20 RESPONSE TO COMMENTS

The Draft Environmental Impact Report (DEIR) for the Coyote Creek Agrivoltaic Ranch Project (the project) was circulated on March 5, 2025 (State Clearinghouse Number 2022010271) for a public review period that ended on May 5, 2025. A total of 74 individual letters were received during the comment period and one additional letter was received after the close of the public review period. This Final EIR (FEIR) provides responses to comments received on the DEIR. Each letter has been assigned a number, as indicated below.

Plate RTC-1: Proposed Project Site and Prairie City SVRA

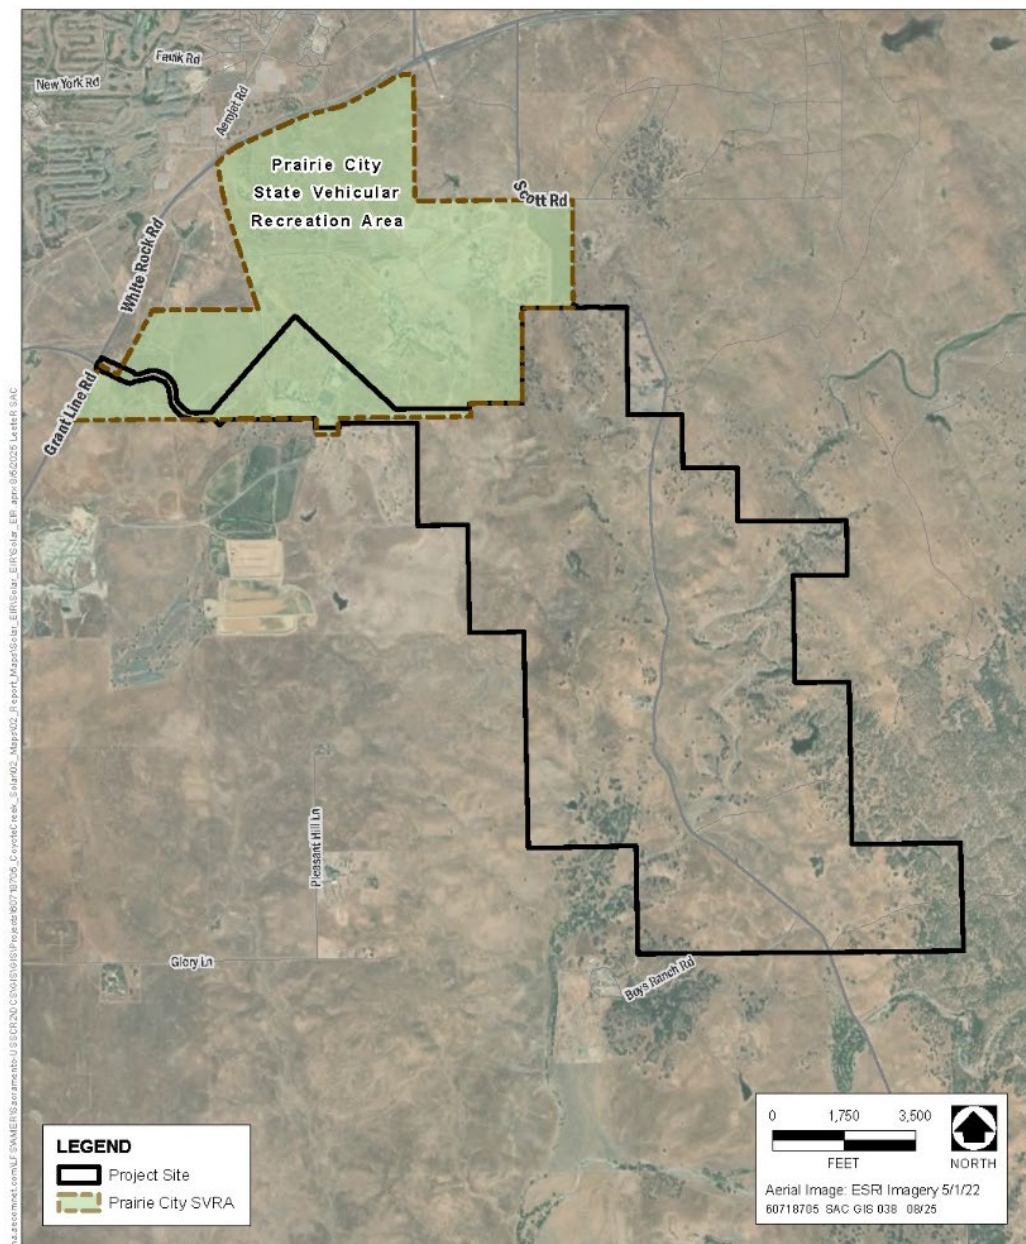
RESPONSE A5-7

The commenter requests that the FEIR include the current PCSVRA boundary. The FEIR has been revised to include the updated PCSVRA boundary on Plate RTC-1. The Sacramento County GIS system has been updated to incorporate this information.

COMMENT O1-23**Figure 1. SMUD-Developed Local Solar + Battery Projects****Under Construction and Supported by 350 Sacramento¹.****RESPONSE O1-23**

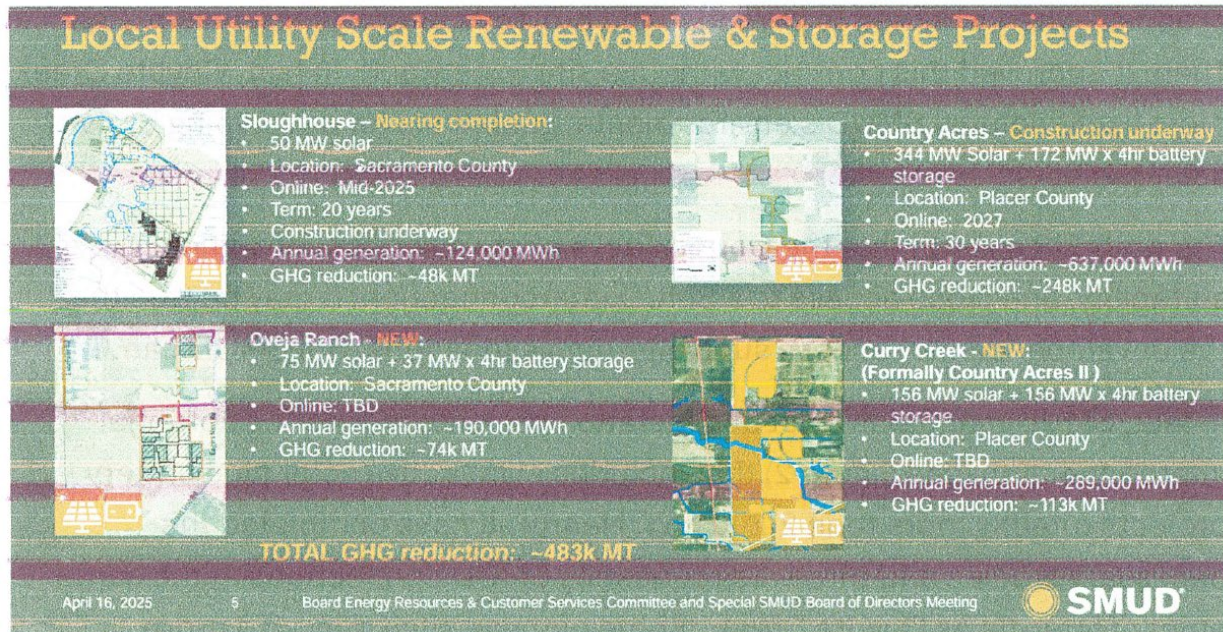
Thank you, Commissioners. My name is Rick Codina and I am with the SMUD Watch Team for 350 Sacramento. We are a local climate action group that supports SMUD's Zero Carbon plan and the many renewable projects they have advanced (see Figure 1).

Refer to Master Response D regarding site alternatives. The comment does not raise any specific issues regarding the adequacy of the EIR analysis.

Figure 1. Location and extent of blue oak woodlands within and near the proposed Project area. Map prepared for Sierra Club.

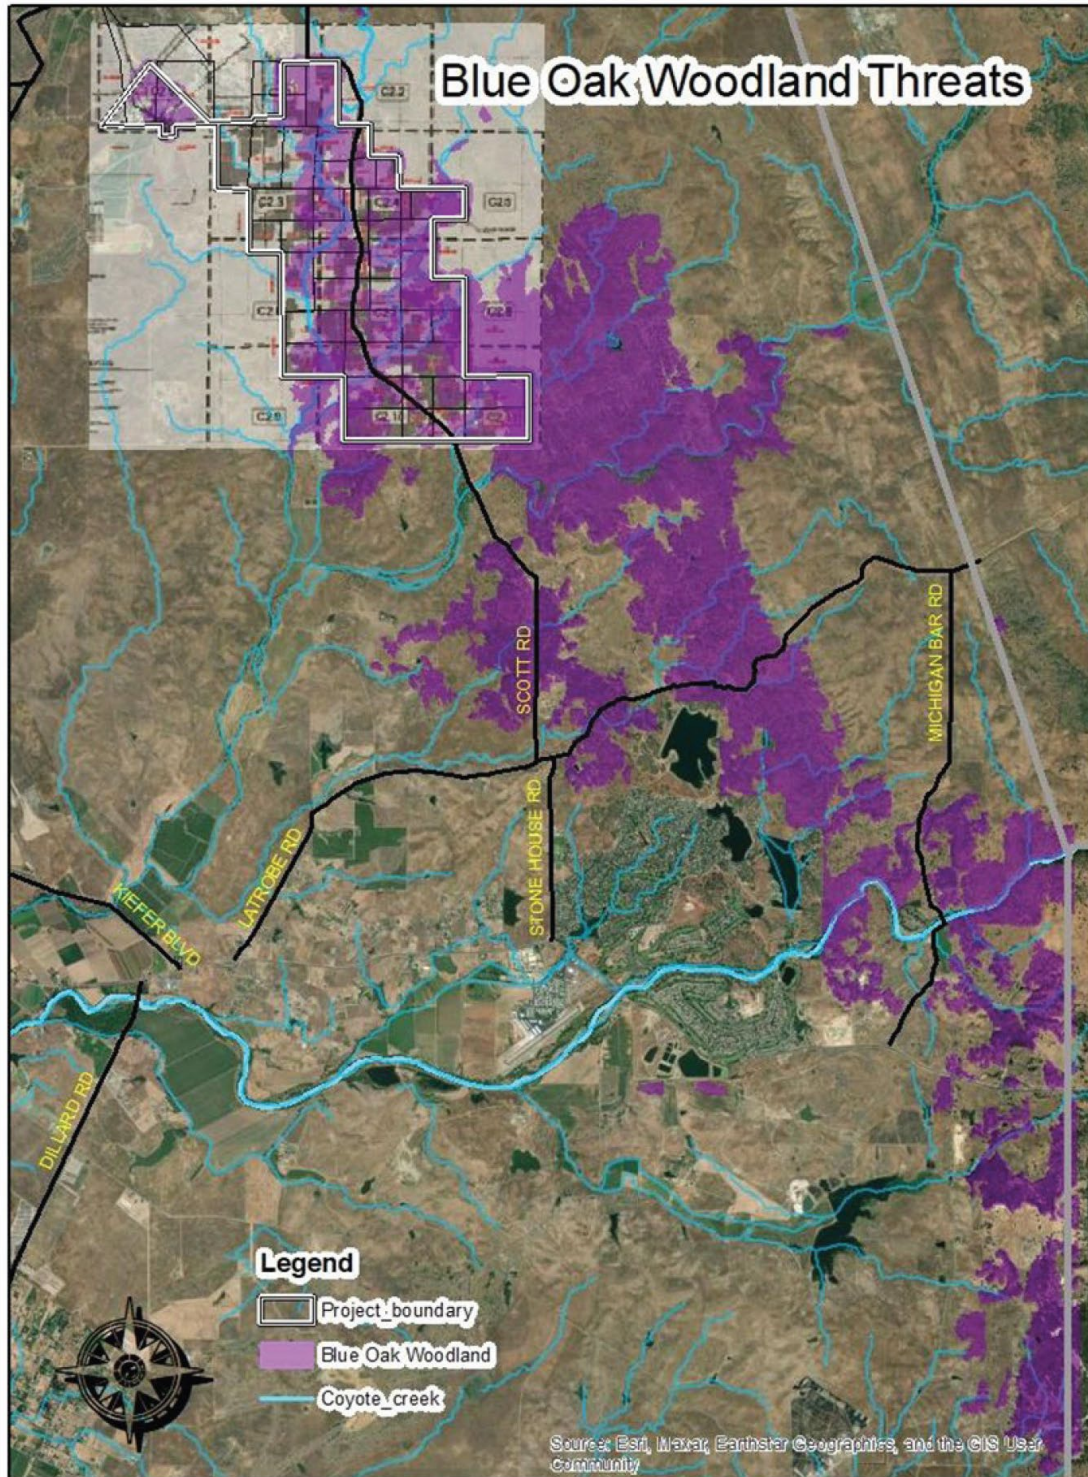
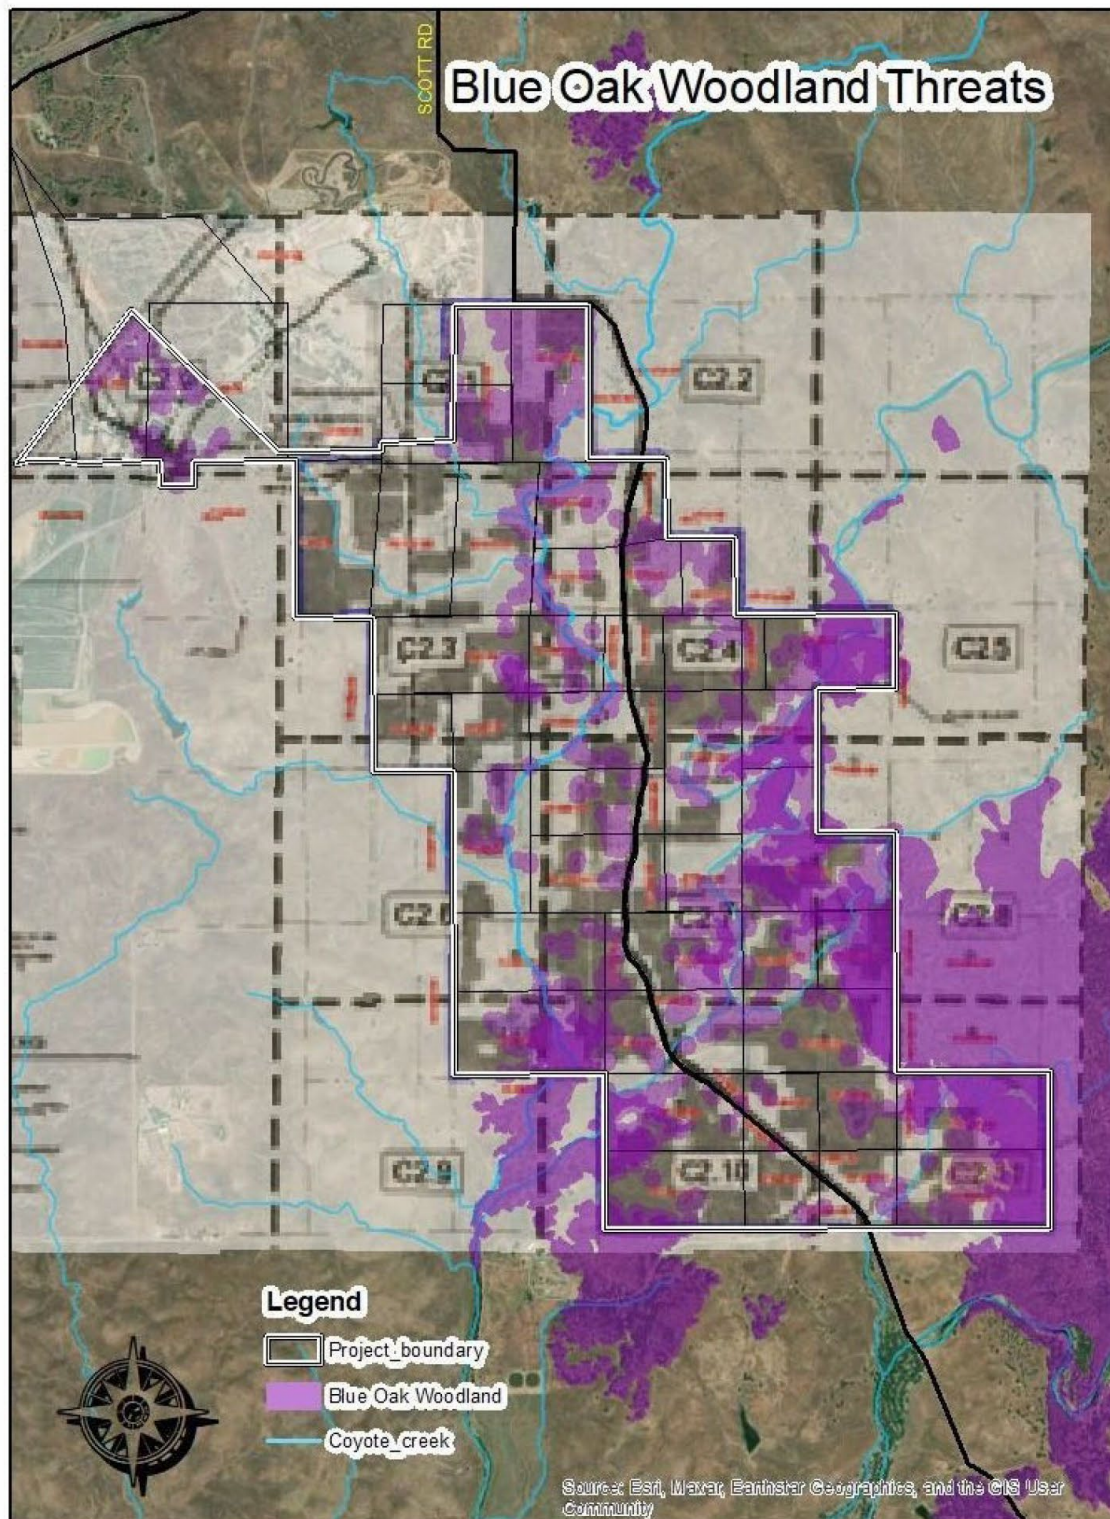
The proposed Project site supports many species of native trees, notably the blue oak, interior live oak, valley oak, unidentified oak species, and Fremont cottonwood (see Figures 1 and 2, which show the location and extent of blue oak woodlands within and around the proposed Project area). The DEIR (DEIR, p. 6-11–12) states that an inventory of all trees within the solar development area and proposed Project site was conducted, but later states that the entire proposed Project site was not surveyed for individual trees (DEIR, 6-13), implying that there are more trees than reported. The inventory of all native trees within the proposed Project site must be provided to give the public an understanding of the significant impact of the loss of native trees.

Figure 3. Location of the Project area in relation to connectivity corridors.

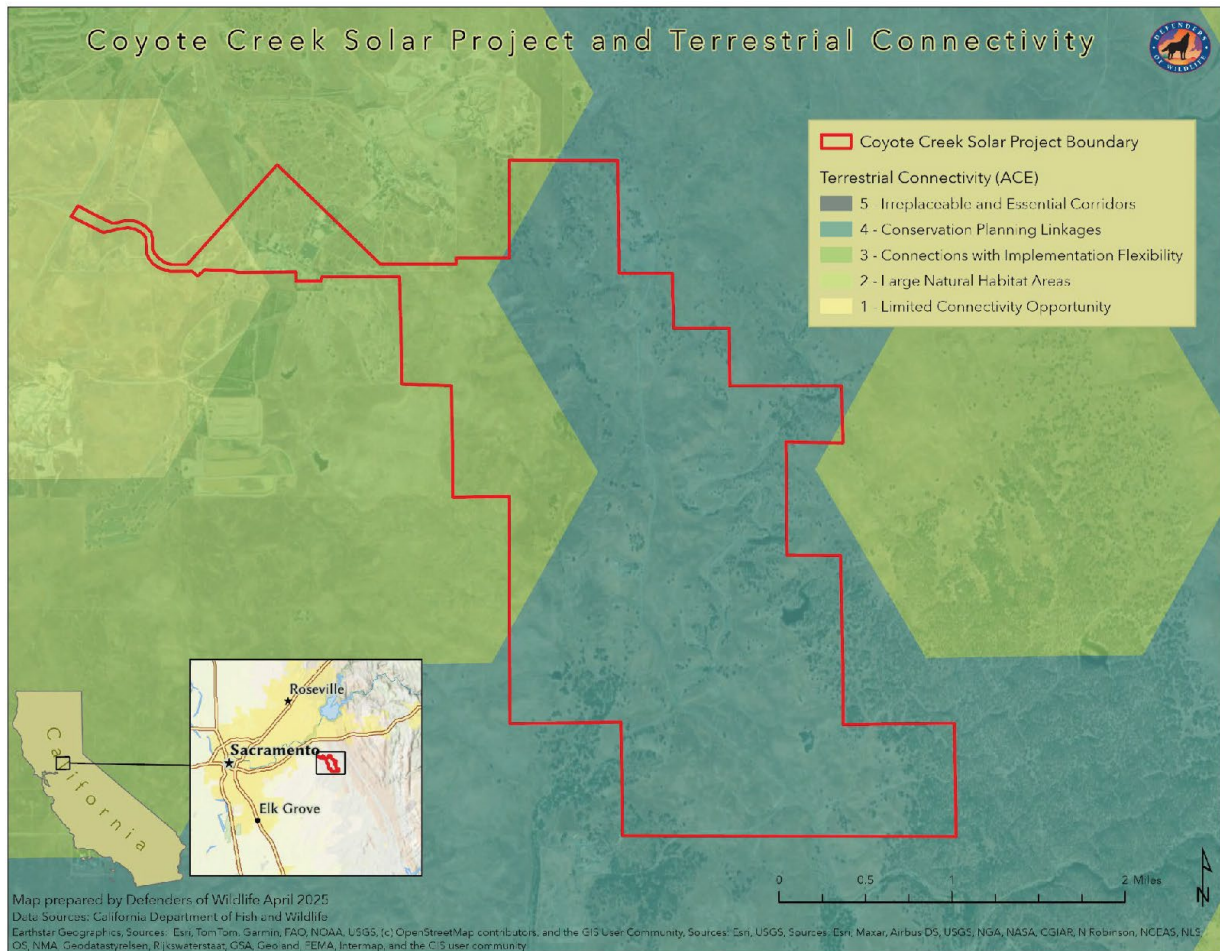
We present maps from the SSHCP the proposed Project area in relation to priority corridor areas in eastern Sacramento County (Figure 3), terrestrial intactness of the land (Figure 4), and terrestrial biodiversity (Figure 5).

The comment provides Figure 3, which shows the location of the project site in relation to connectivity corridors. The figure is noted and will be included in the project record. Refer to Master Responses B1c and C. Note that the project has incorporated permanent preservation of habitat within and adjacent to the project site that contributes to long-term habitat connectivity (see Mitigation Measure BR-2b).
